ARCHITECTURE DESIGN REPORT
SECTION 4.55 APPLICATION - AREA 13,14 & 15 ST LEONARDS SOUTH
14-16 MARSHALL AVE, 5-9 HOLDSWORTH AVE & 2-10 BERRY RD, ST LEONARDS

PREPARED FOR DASCO PROPERTY DEVELOPMENT PTY LTD
May 2025
REV.02

Design Verification Statement

**Design Statement to assist with the
Section 4.55 Application**

Figure 1: Non-compliant setbacks for Bldg 14.

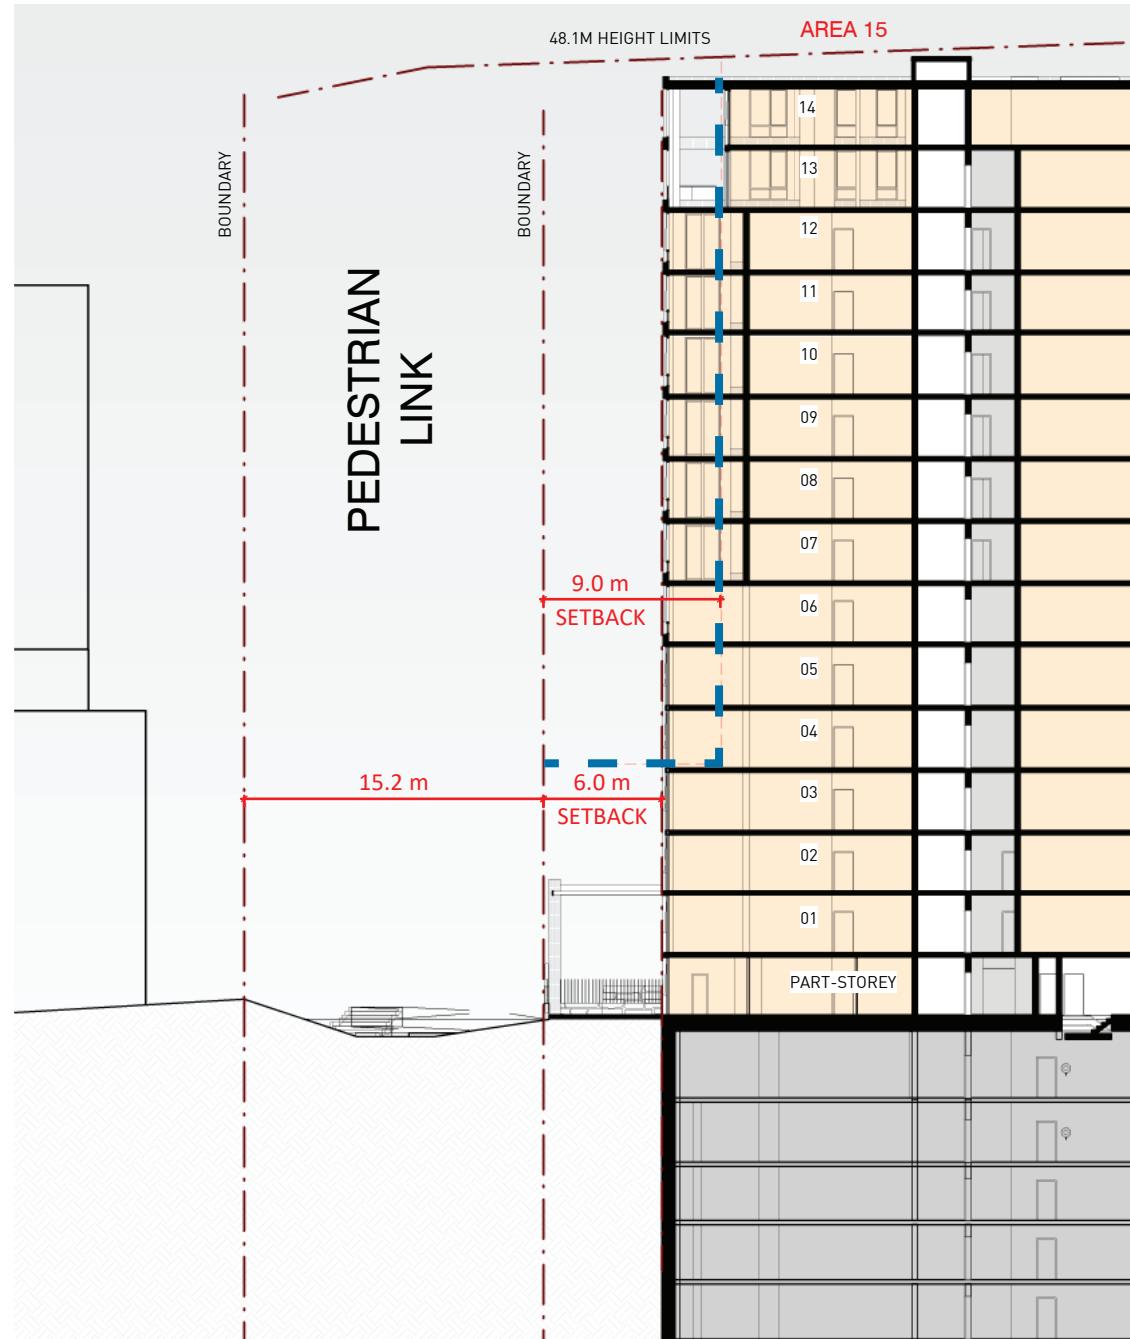
COUNCIL LETTER [19/08/2022] 2.2 East/West Link

Buildings Setbacks F: - from east/west pedestrian link requires:

- 6m setback at park level to level 4
- 9m setback at and above level 5.

The application proposed a 6m setback at all levels from the east/west link. Although the proposal complies on ground floor to level 4, the controls require an additional 3m from level 5 and above.

Levels 5 and above do not comply with the 9m setback control.

A 6m continuous setback is provided to the pedestrian link, therefore the proposal does not comply from level 5 and above. justification is provided on the following page.

RESPONSE:

Visual impact associated with the upper-level non-compliance, the following design justifications are provided:

Reinforcement of Tower and Podium Form:

Despite the non-compliance, the architectural intent of a clear tower and podium composition is retained through the use of contrasting materials, colours, and forms. The podium facade is in earthy brick, textured material palette, while the tower elements above are treated with lighter tones and expression of vertical articulation, helping to visually separate the built form and maintain the intended hierarchy.

Minimised Visual Impact from Pedestrian Link:

Area 14 and Area 15 the proposed massing shapes the pedestrian link and the non-compliant tower element helps strengthening the direct sight-line corridor, together with integral of landscape design. The articulation of the façade and the transitional scale between podium and tower levels help reduce the perceived bulk and visual dominance at the pedestrian scale. Providing windows and balconies overlooking the pedestrian link(potential for passive surveillance and safety). Additionally, a pergola structure at the ground level softens the building edge and provides a more human-scaled, visually appealing interface with the public domain.

These measures ensure the overall massing remains visually appropriate, with minimal impact to the public domain, while still achieving the broader design objectives of the development.
